Access Compliance Report Public Rights-of-Way (Pedestrian Signals)

Main Street: **CANNON_ST** Cross Street: **CHAPMAN_AVE** Location: **NE**

ADA ID: **SGRK220103111933** Signal Type: **One Push Button-Non APS** Overall Compliance: **No** Severity Scores: **BTN 1: 35** **BTN 2: N/A** **No BTN: N/A**

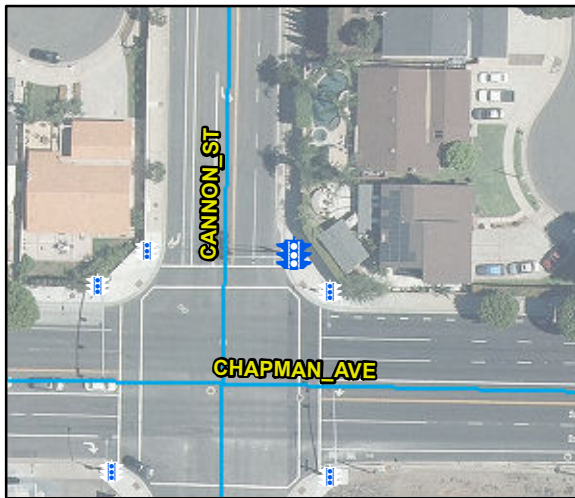
OC Std/PROW: **MUTCD 4e.08, R404.2**

Possible Solutions: Replace Signal Push Button With APS Button. Remove & Relocate Sign.
